Eastern Connecticut State University Willimantic, Connecticut 06226-2295

HEAT PLANT SECONDARY PUMPS REPLACEMENT

Project: ECSU 2019-3

ADDENDUM NUMBER 1

UNIVERSITY	
RN CONNECTICUT STATE	Facilities Management and Planning 83 Windham Street, Willimantic CT 06226
EASTERN COL	83
A Revision No. Revision/Issu BUILDING: NORTH HEAT PROJECT NAME	T PLANT
SECONDARY REPLACE	MENT
MECHANICAL AND EQUIP SCHEDU	MENT
ECSU-201	9-3 wing No.: M-2

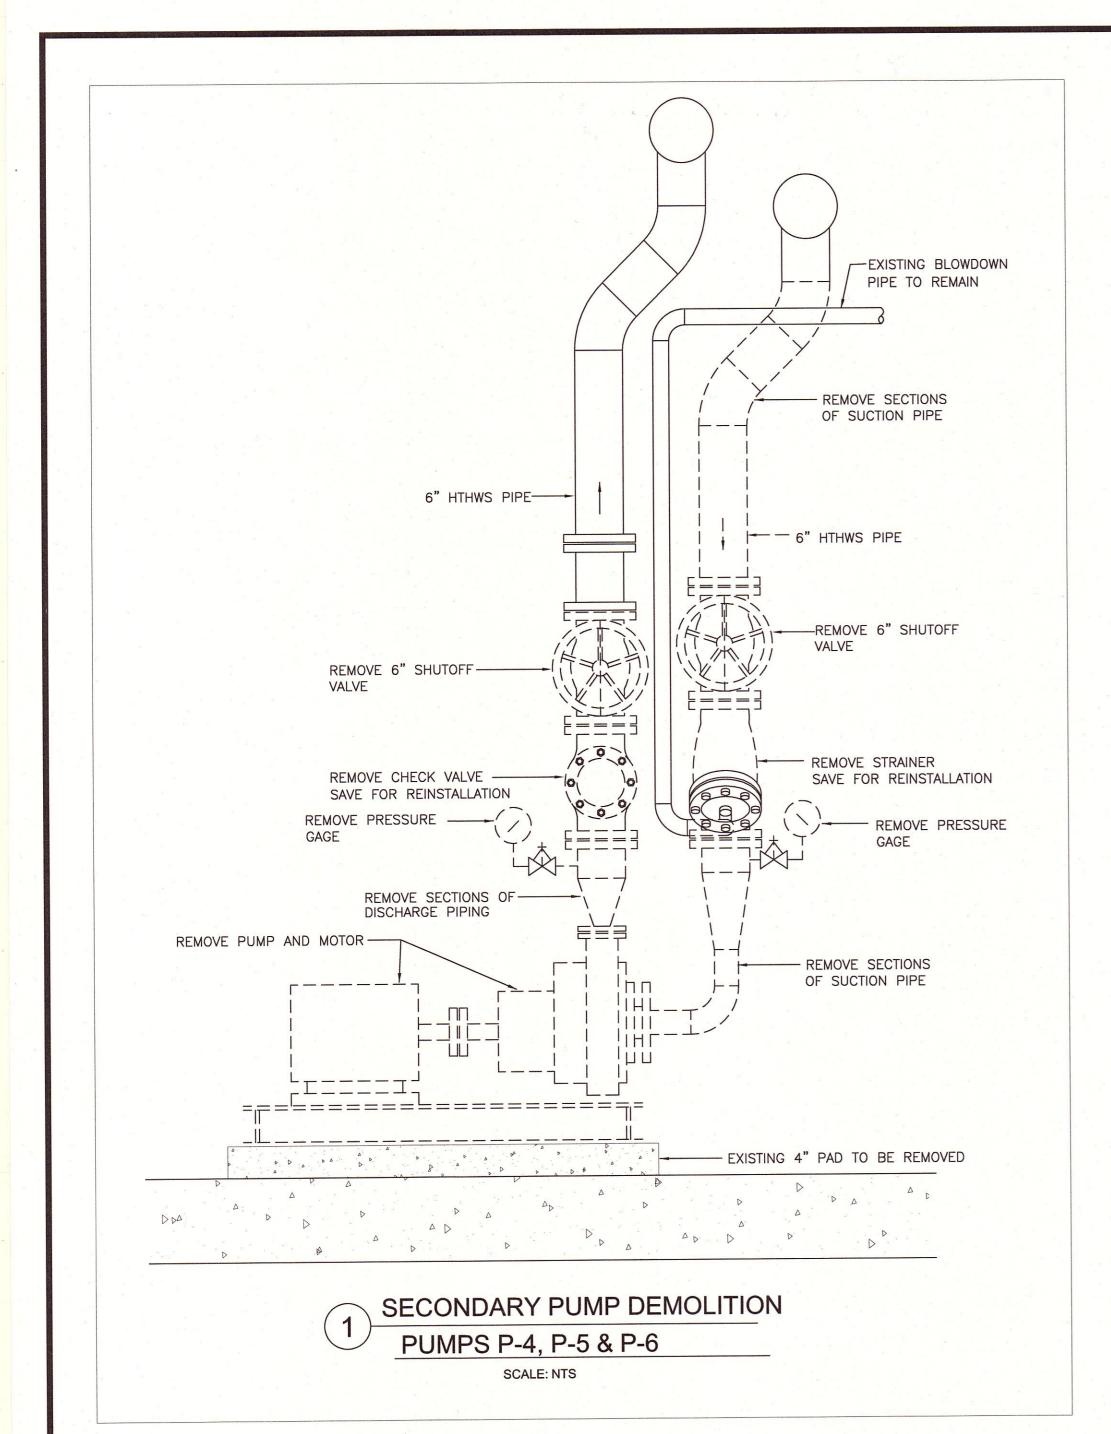
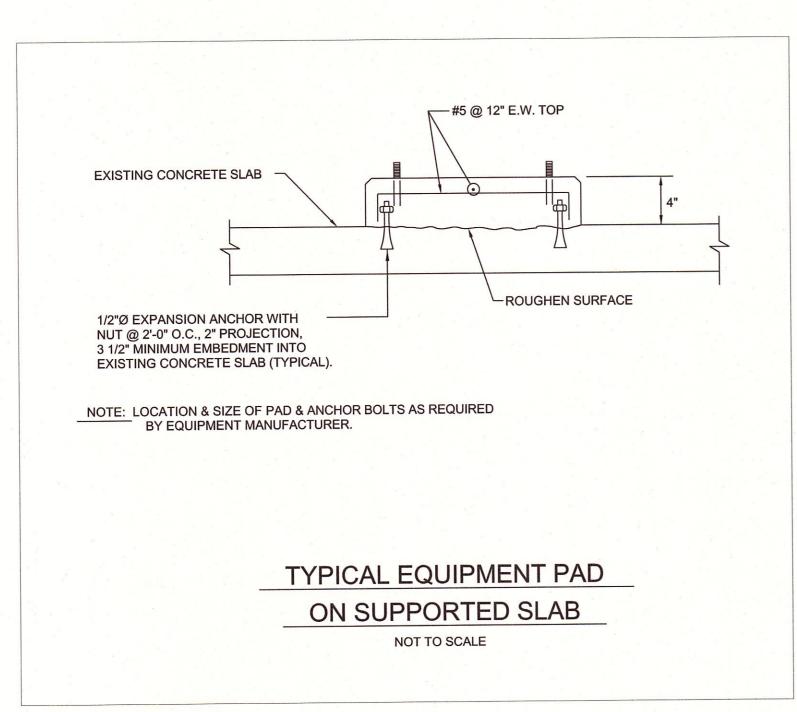
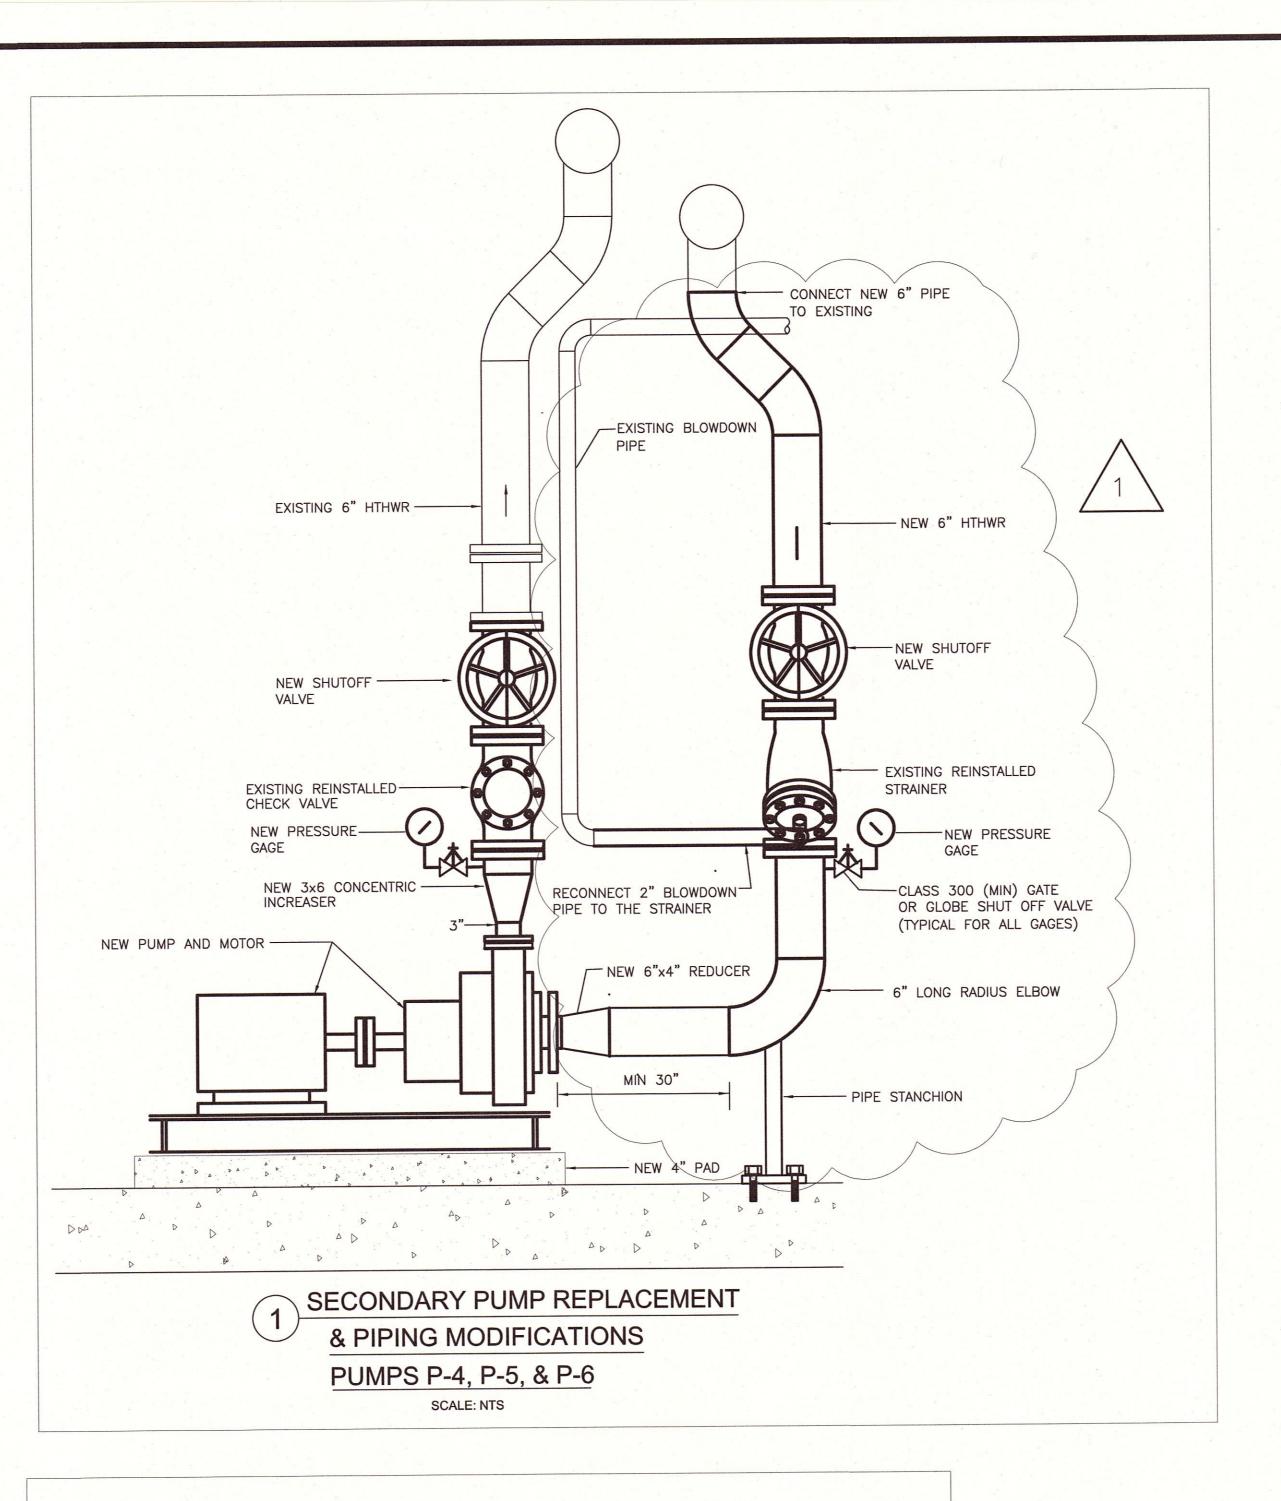
ITEM 1: The attached drawing M-2 shows revised configuration of the suction pipe connected to pumps.
